1960 Corvette: Service Bulletin: Instrument Lens Cracking and Checking

Subject: Instrument Lens Cracking and Checking

Bulletin No: DR #448

Date: August 23, 1960

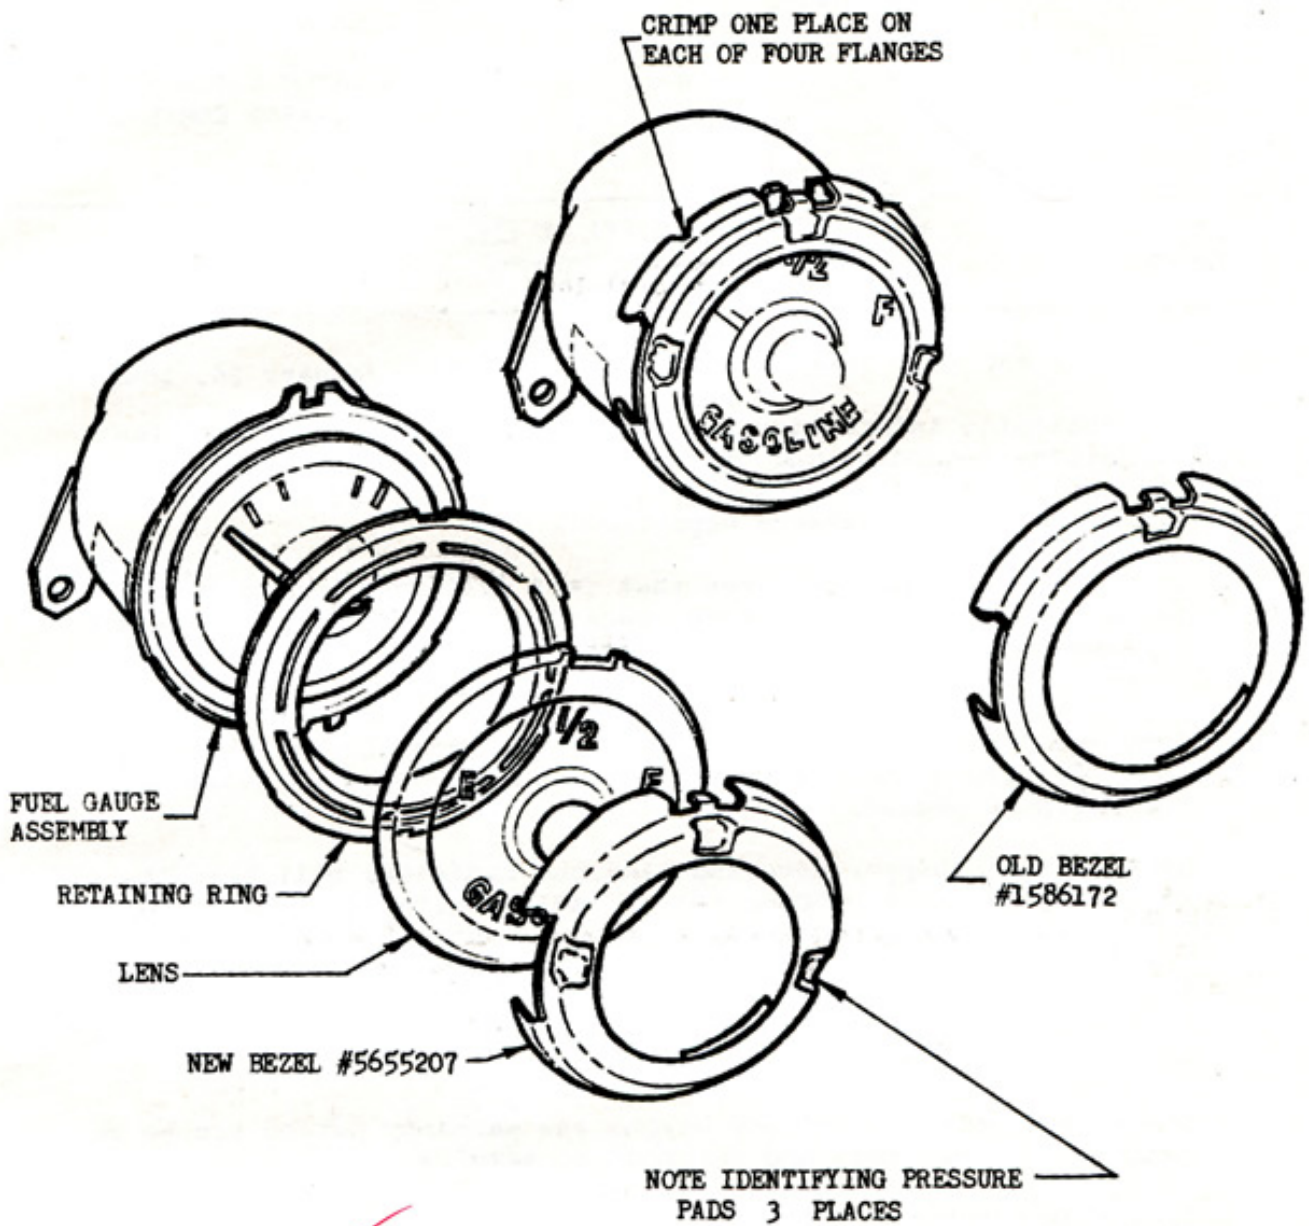
Field complaints of instrument lens cracking or checking on 1960 Passenger Cars have been traced to the means of lens retention in the various instruments.

A revised retaining bezel has been released for production and is available in Service Parts Stock. Three bezel pressure pads have been added and the number of crimps has been changed from eight to four as shown in the illustration.

When replacing a damaged lens, it will also be necessary to replace the first design bezel with the revised bezel listed below. no changes has been made to the individual fuel, temperature and tell-tale lenses.

5655207 -- Bezel

The new bezel should be crimped in one place on each of four flanges as shown in sketch after it is positioned over the lens. When reinstalling gauge

assembly to instrument panel, tighten mounting screws a minimum amount necessary to remove looseness and rattle of the lens. Do not overtighten!
